OFFICE MEMO

FILE REF: Proposed Plan Change
TO: Alyson Schuler
FROM: Rebecca Ramsay (Landscape Architect)
DATE: 27.06.2005
SUBJECT: The Kirimoko Block - Wanaka

APPENDIX 2: CONCEPT PLAN 'VERSION 2'

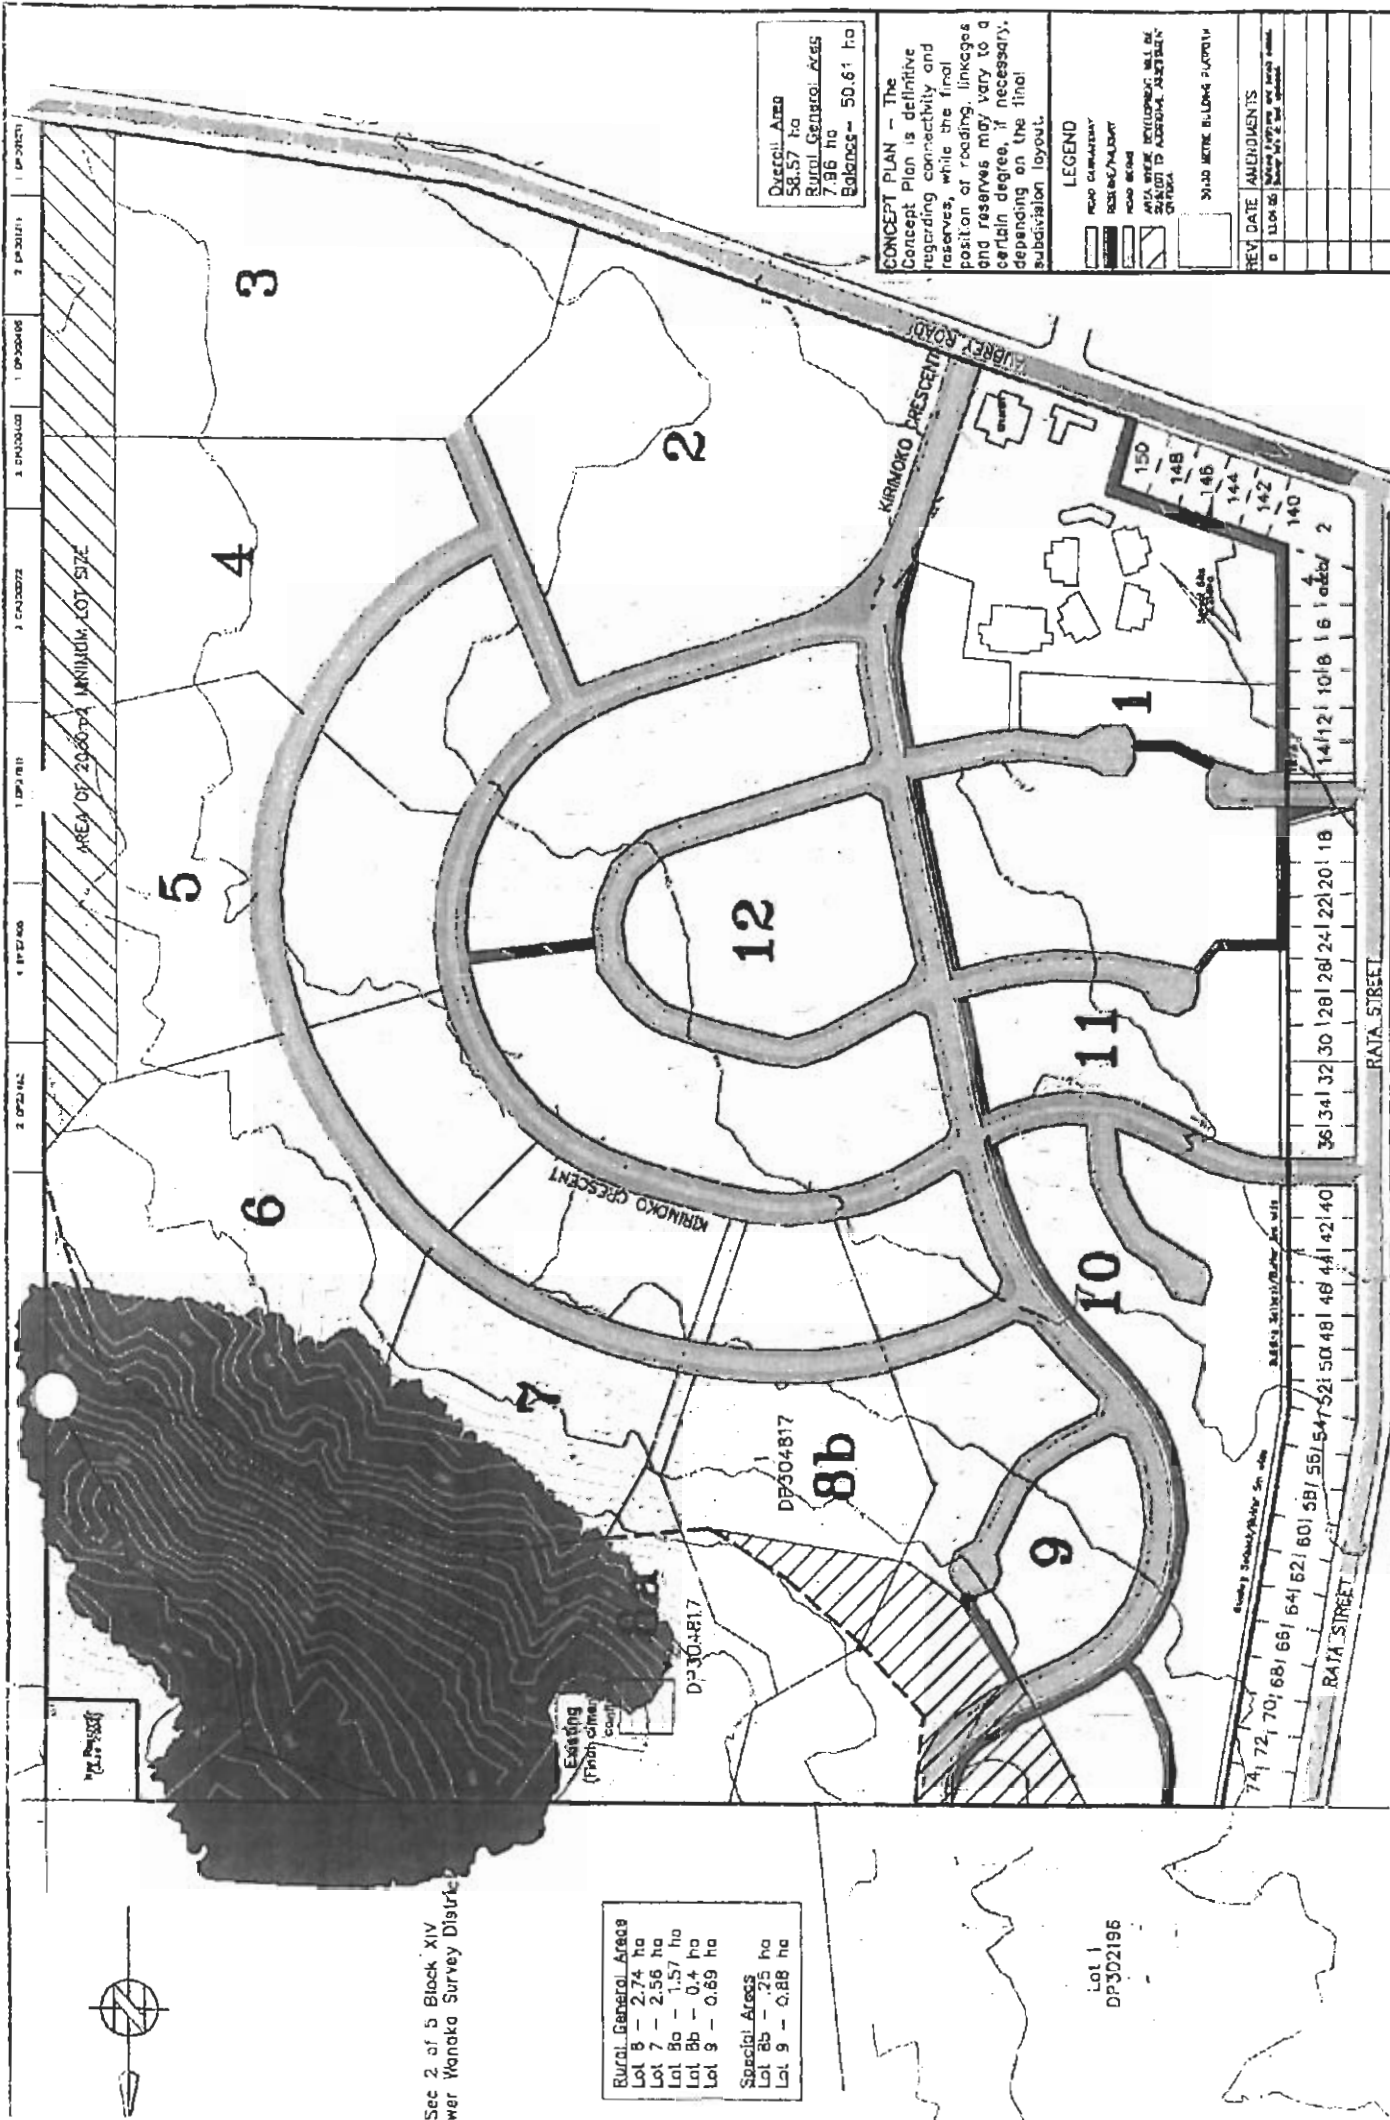
- Visibility of the site.
 - Effects on and location of existing residential areas and development.
22. On May 4th I again spent time on the site and was presented with a new plan (attached as Appendix 2) indicating some amendments to the original plans. This most recent proposal includes the following aspects:

31. This would indicate that the "further restriction area" as drawn on the May 4th plan (where it meets the northern boundary) is in a location that could be considered consistent with the findings of the Court in terms of an upper limit for residential use that provides for protection of landscape values. The upper limit for residential development as accepted by the Environment Court within the Peninsula Bay land meets the northern boundary of the Kirimoko Block at approximately the 345m contour line.

32. The line as indicted on the Version 2 concept plan begins at the 345m contour at the northern boundary then travels around the slope within lots 9 and 8b rising to meet the lot 8a boundary at

the 350m contour. I believe the upper limit line should in fact continue around the slopes of Lots 9 and 8b at the 345 contour. While use of a contour line could be considered a somewhat arbitrary form of defining an upper limit for development, the landform within Lots 9 and 8b is an open rounded slope that does not have the distinct change in slope and vegetation patterns as seen on the Peninsula Bay land. Cues for defining an appropriate upper limit can not be readily taken from vegetation patterns and topography within Lots 9 and 8b but must be considered at a wider contextual scale in terms of consistency with upper limits on adjacent land and logical connections as seen from more distant views of the site where the importance of the natural landscape as a backdrop to existing and future residential development is more readily appreciated.

42. I was able to carry out an assessment of the proposed zone boundary line (as shown on the Version 2 plan) through walking between pegged points on the ground and roughly connecting a line. Trees within the forest were also marked. Within the forest it is clear that the proposed line is a considerable distance from the ridge that runs through the north eastern corner of the site. It is my understanding that the contour information has somewhat limited accuracy as surveying amongst trees is difficult; however, the contours appear to generally translate to what is on the ground.

43. From the eastern boundary the proposed zone boundary traverses the slope past a small gully than rises slightly to include an area of shallower sloping ground, before following along below a very steep slope. The site has areas that slope evenly up to the north east and more varied slopes where a series of gullies run down the slope. These undulating parts of the site (see photo 1 below) are very similar to parts of the Peninsula Bay land in that there are distinct across slope undulations that complicate the south west fall of the land.

46. The approved building platform within Lot 7 appears to be considerably lower on the site than the proposed platform (around 30m in elevation). The proposed Rural General boundary appears to exclude all of the building platforms previously approved under the original 12 lot subdivision of the property which is consistent with the previous consent. The proposed zone boundary is however, higher up the slope through Lots 6 & 7 with the area where design controls are proposed within Lots 9 and 8B also higher than approved building platforms.

64. As discussed above, I consider that in order for the character of the upper slopes of the site to be suitably maintained, it would be better to lower the zone boundary line to a well thought out location as discussed previously, rather than rely on a more complicated "buffer area" with additional rules and assessment matters.

**APPENDIX 3: PHOTOGRAPH LOOKING TOWARDS THE SITE
(IN AN EASTERLY/NORTH EASTERLY DIRECTION) FROM
THE SURFACE OF LAKE WANAKA IN THE VICINITY OF RUBY
ISLAND.**

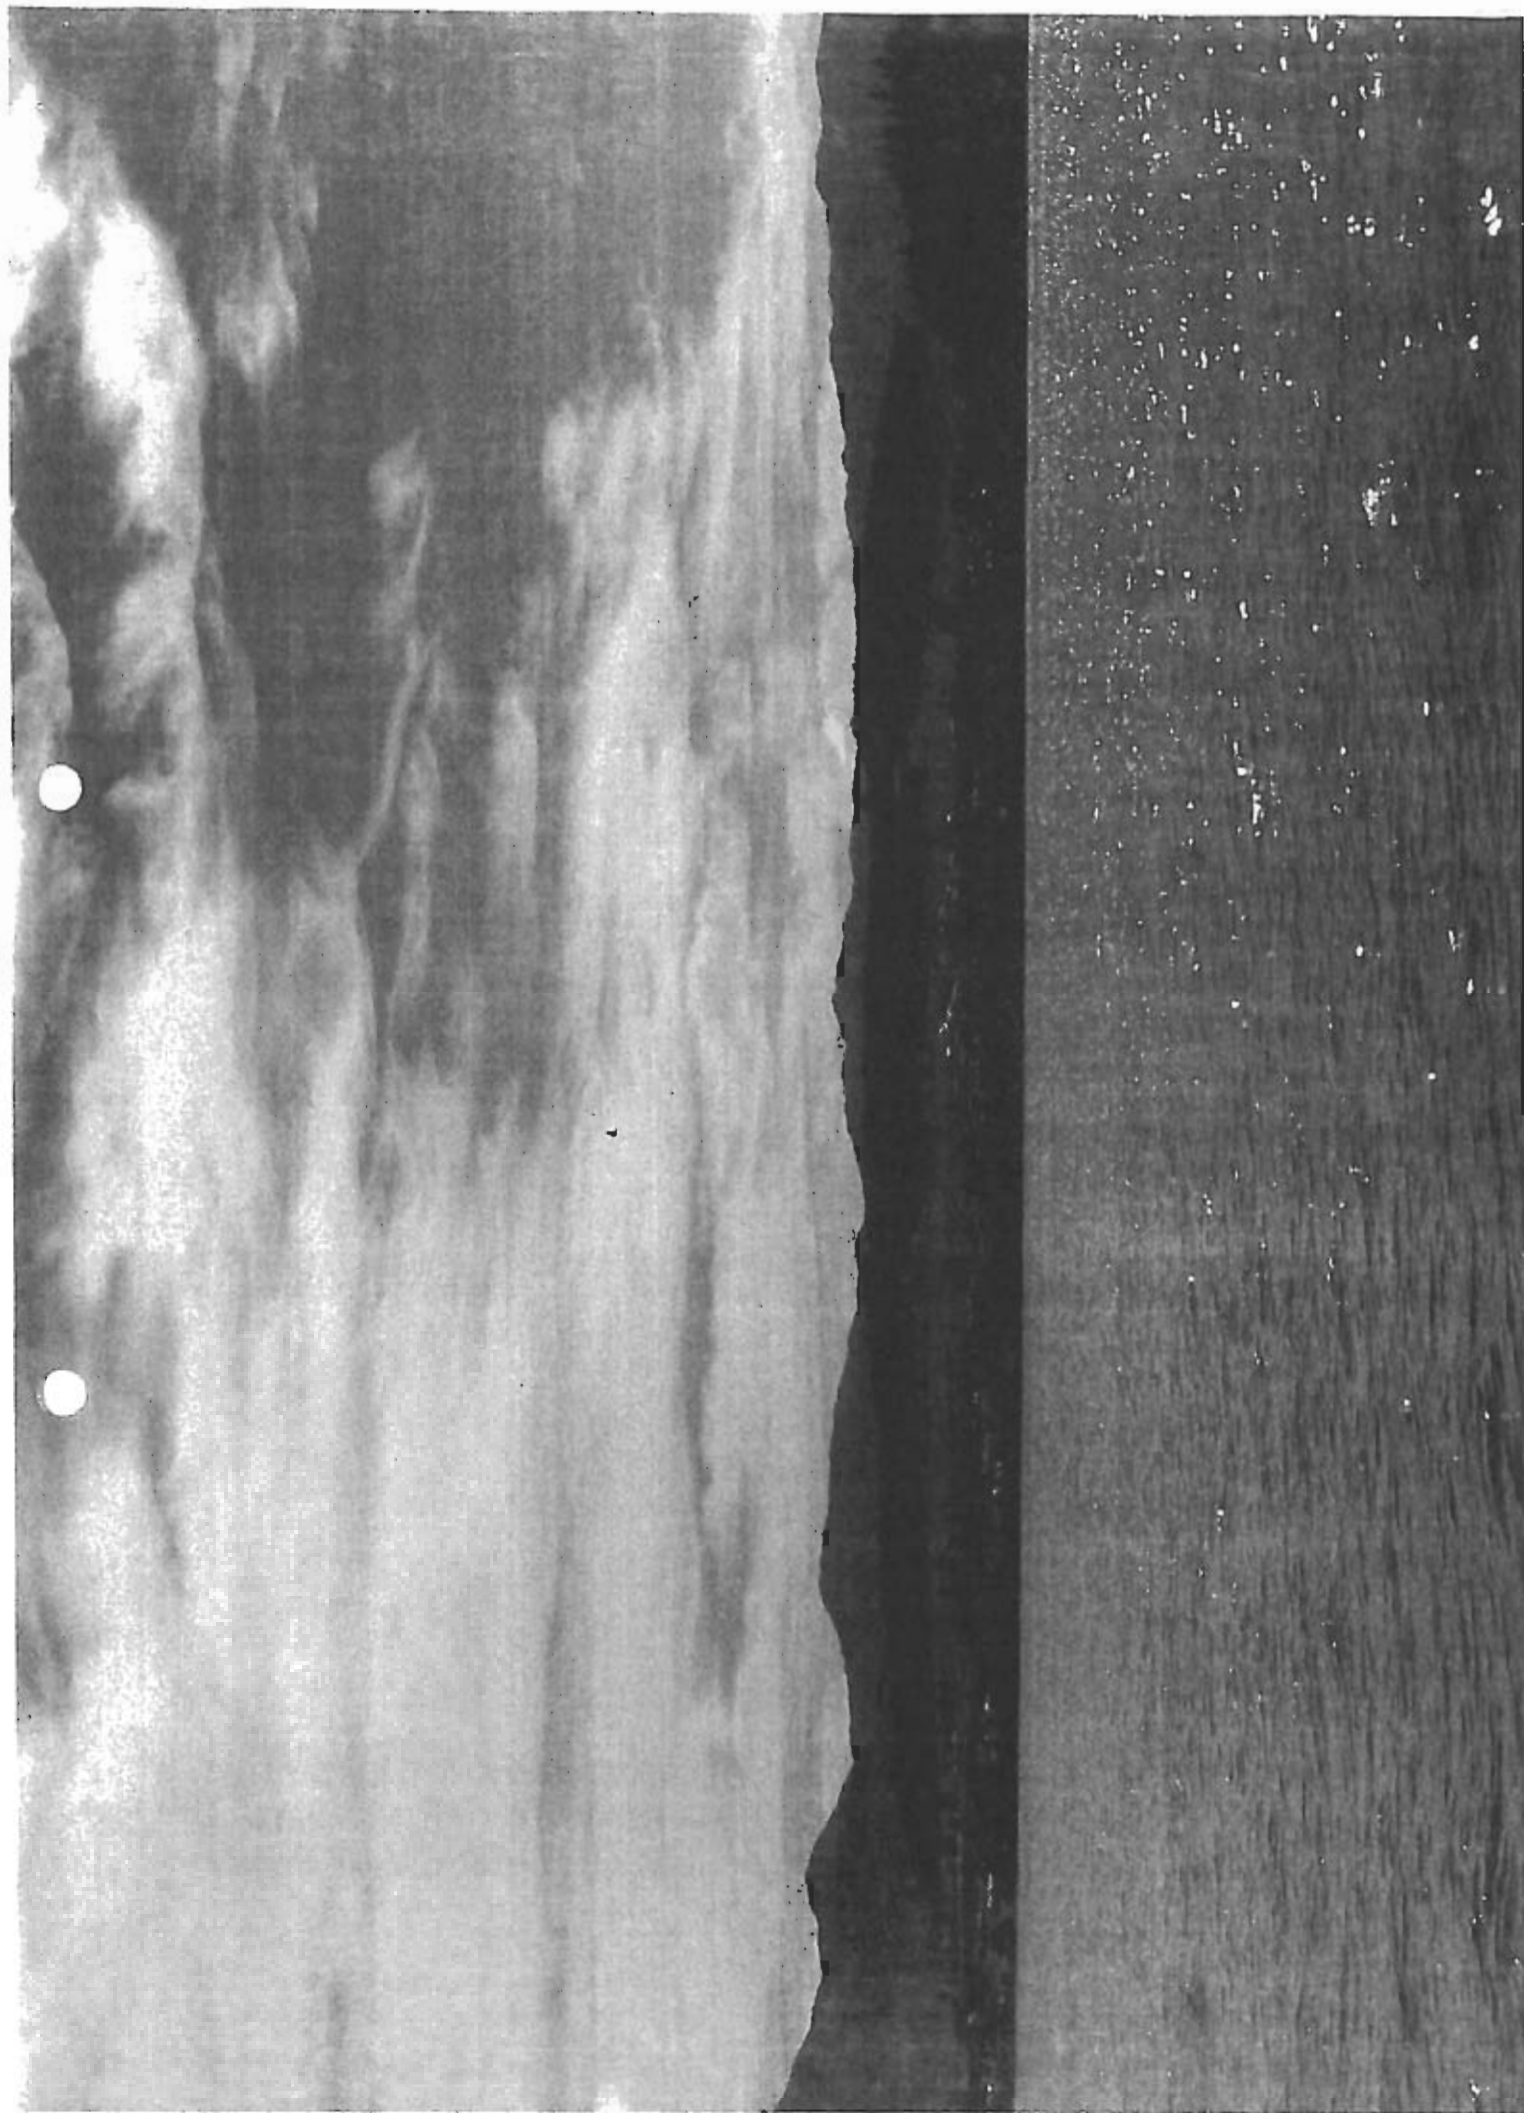
24. Appendix 3 is a photo taken from in the vicinity of Ruby Island on Lake Wanaka. This photo shows the land form that stretches out to the north of Wanaka town centre. It is possible to see a dwelling in the photo relatively high on the slope to the left of a block of pines. This is the existing dwelling that sits near the northern boundary of the site approximately mid way along the northern boundary and near the 370m contour. This dwelling is well above any of the residential areas of Wanaka. The pine trees closest to the Lake at the right of the photo are the pines at Eely Point.

25. When viewing the site from the Lake it is not until one passes around Eely Point that it is possible to see the site in context with the ridge shown in Appendix 3. Between Wanaka township and Eely Point, topography, vegetation and existing residential development obscure views towards the Kirimoko Block unless a viewer is well out into the lake. When north of Eely Point the site becomes more readily visible, again however, when close to the shore existing residential development obscures most views of the site.

**APPENDIX 4: CONCEPTUAL MAP INDICATING GENERAL
ABILITY OF PARTS OF THE KIRIMOKO BLOCK LAND TO
ABSORB FURTHER DEVELOPMENT.**

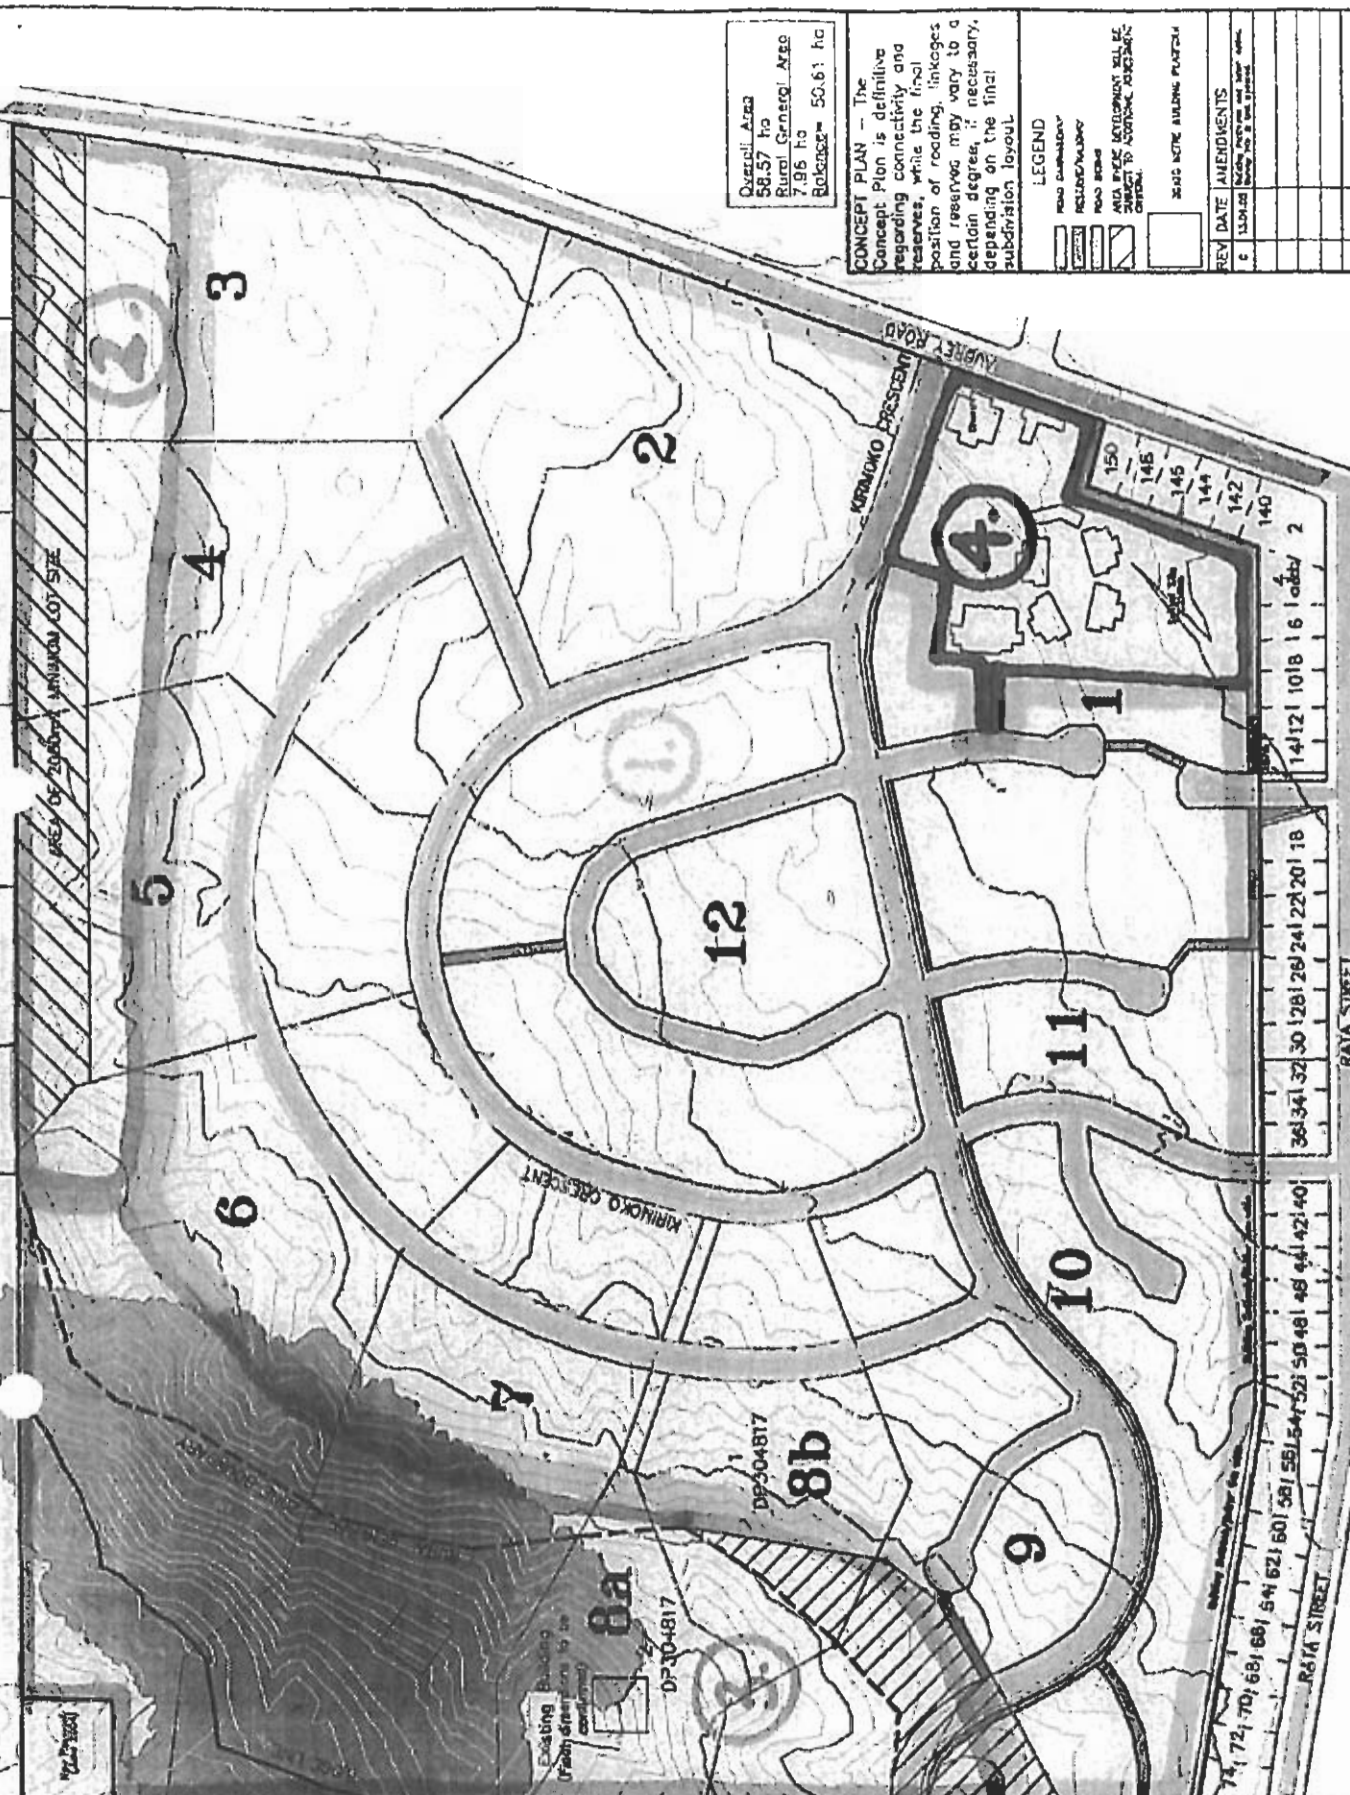
73. Attached as Appendix 4 is a map of the site indicating areas of the site that I consider to be more sensitive due to landscape values. In summary I consider the southern half and most of the western half of the site are better able to contain an increase in residential density without significant effects on wider rural landscape values and without compromising the natural landform that forms a back drop to residential Wanaka as seen from the Lake and areas further a field to the west.

74. The conceptual lines on this map were drawn through consideration of changes in topography, visibility of parts of the site from distant views, vegetation patterns, and the location of existing approved building platforms.
